Planning Board Meeting

October 17, 2023

ASSISTANT PLANNERS REPORT

ASSISTANT PLANNER REPORT

APPROVAL NOT REQUIRED PLAN
17 ADAMSVILLE ROAD
ASSESSOR'S MAP 77 LOT 12, LOT 12D
WESTPORT, MA

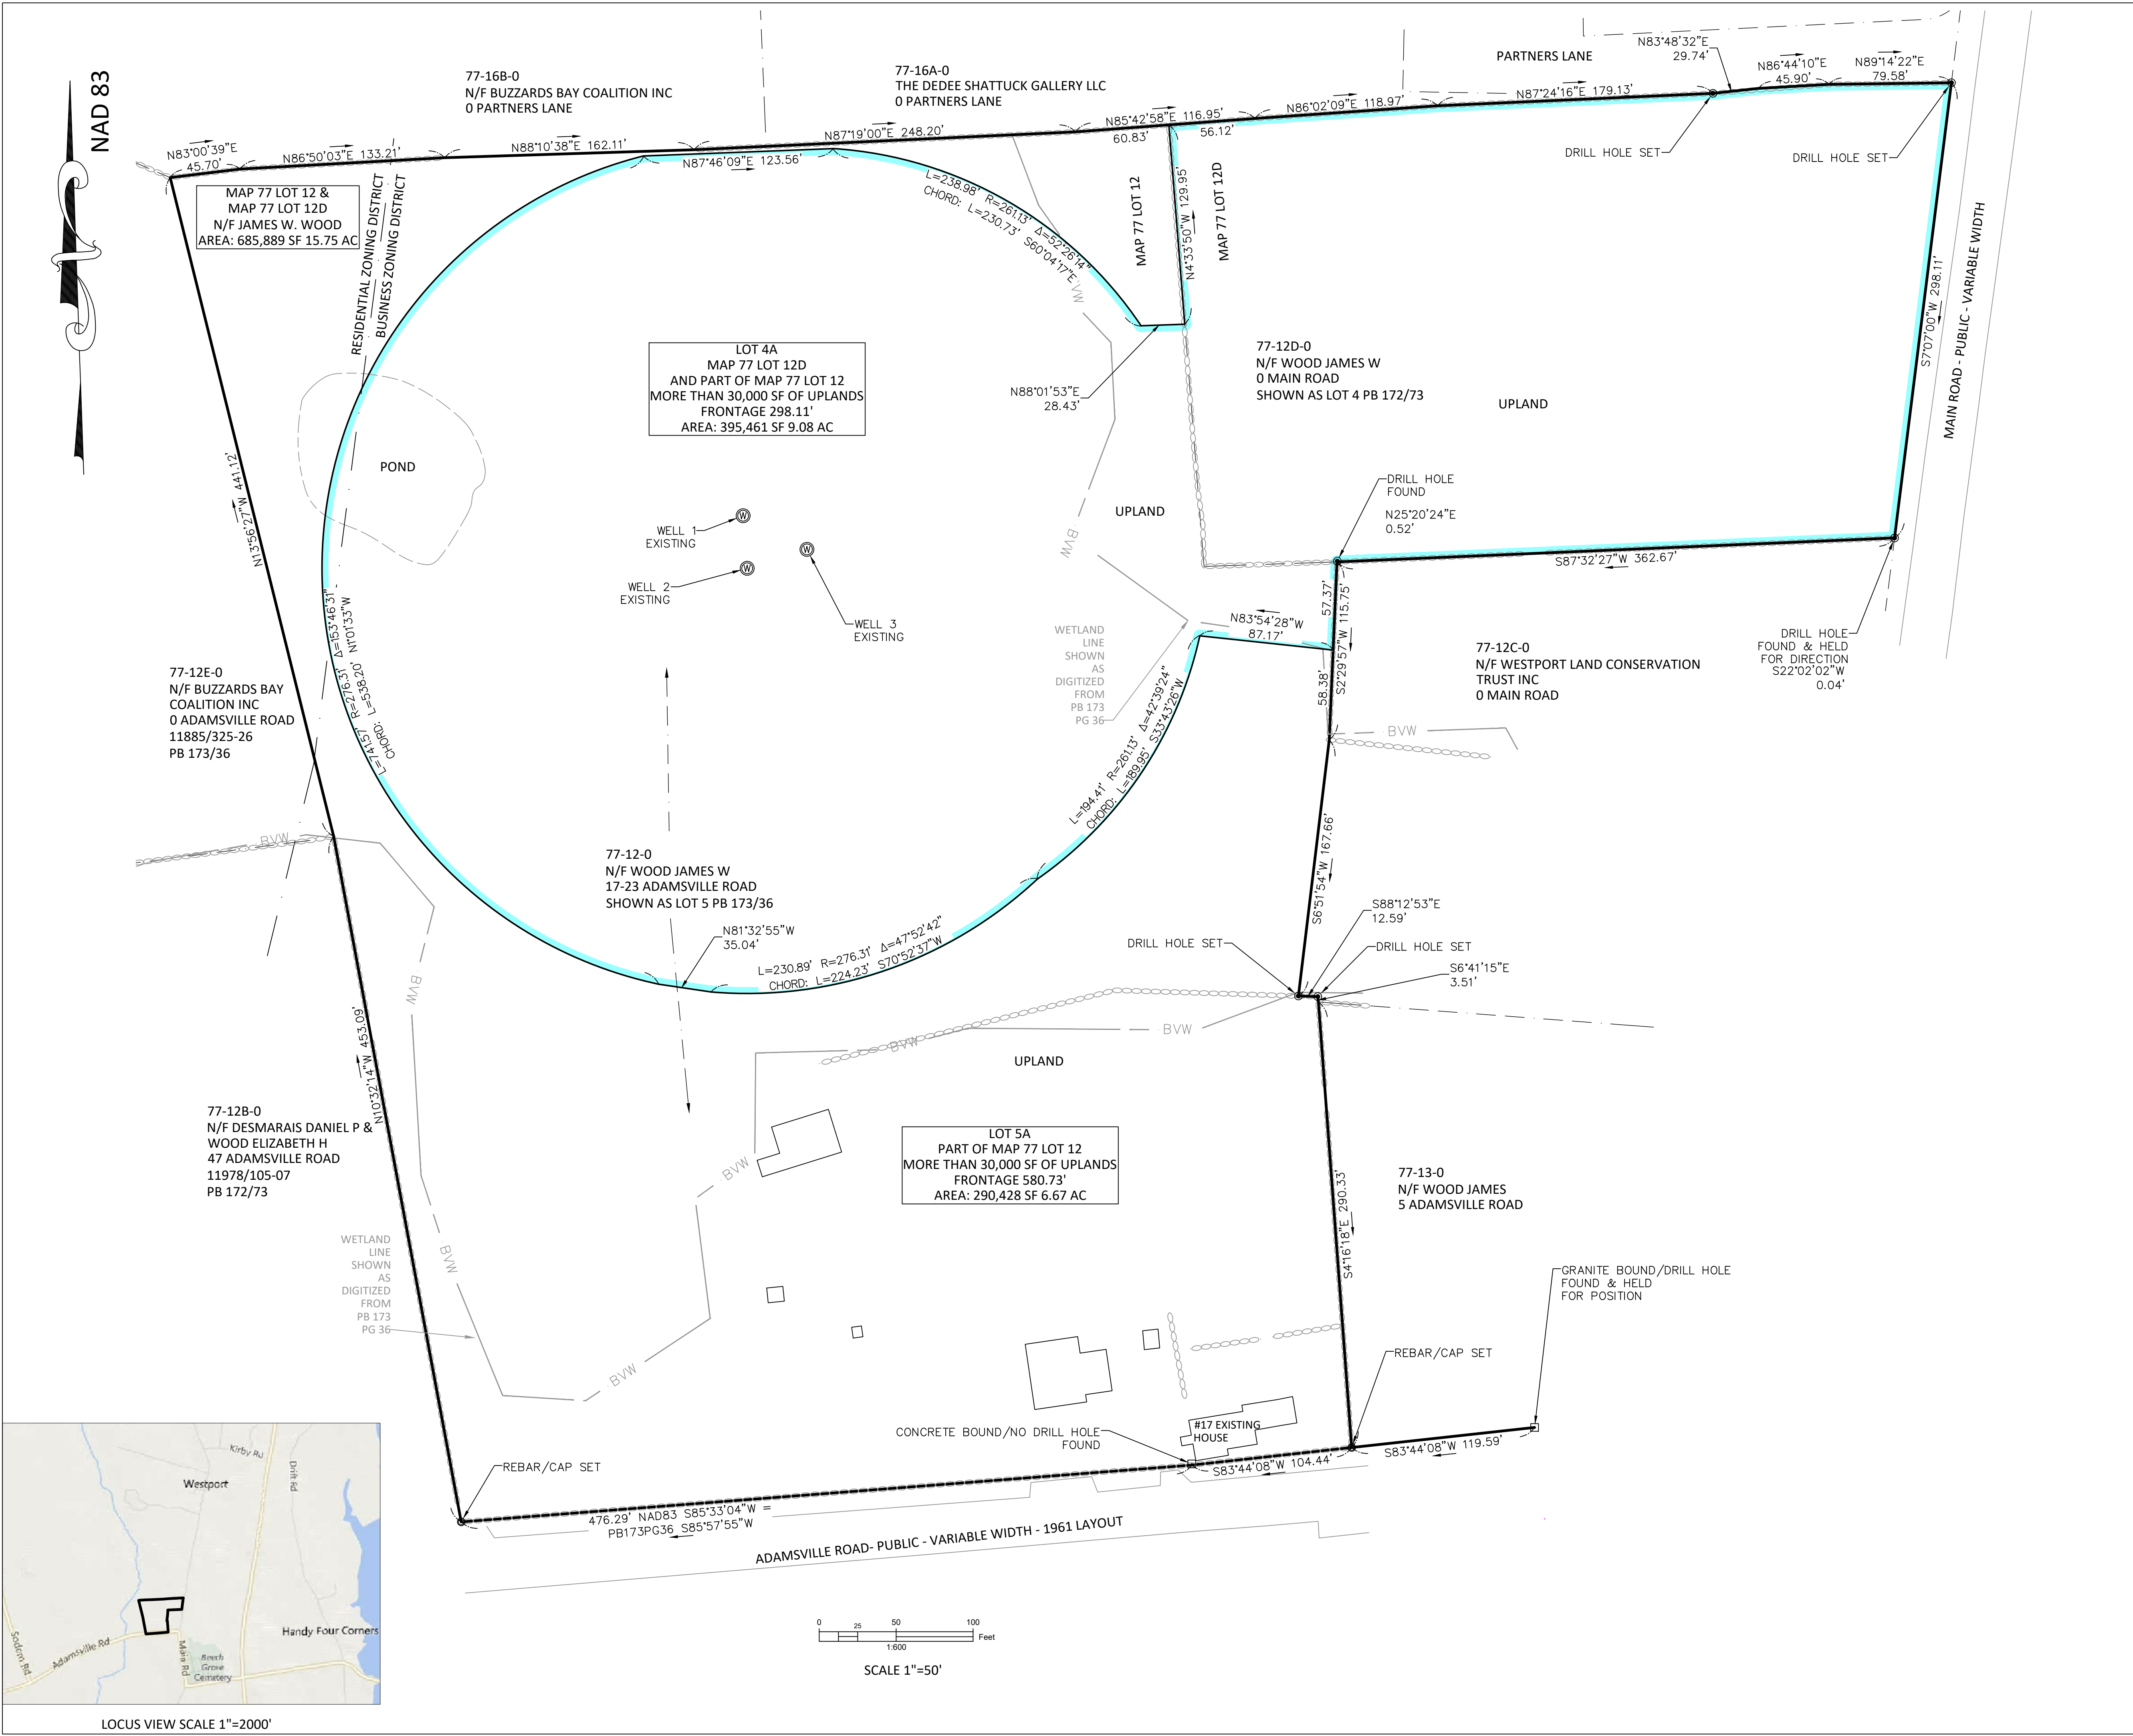
- **There will be no change to Adamsville Rd. or Main rd., both are Town accepted roads that provide sufficient width and suitable grades.**

- **Lot 5A would have a total area of 290,428 s.f. while Lot 4A would have an area of 395,461 s.f.**
- **Both existing lots, and proposed new configured lots have contiguous uplands of more than 30,000 s.f.**
- **The existing house at 17 Adamsville Rd. will remain on lot 5A, while lot 4A does not currently have any structures on it, but could be considered a buildable lot under the current standards within the Westport Zoning Bylaw.**

Staff finds that the proposed ANR meets the criteria for ANR endorsement. Staff recommends that the Planning Board endorse the proposed ANR plan.
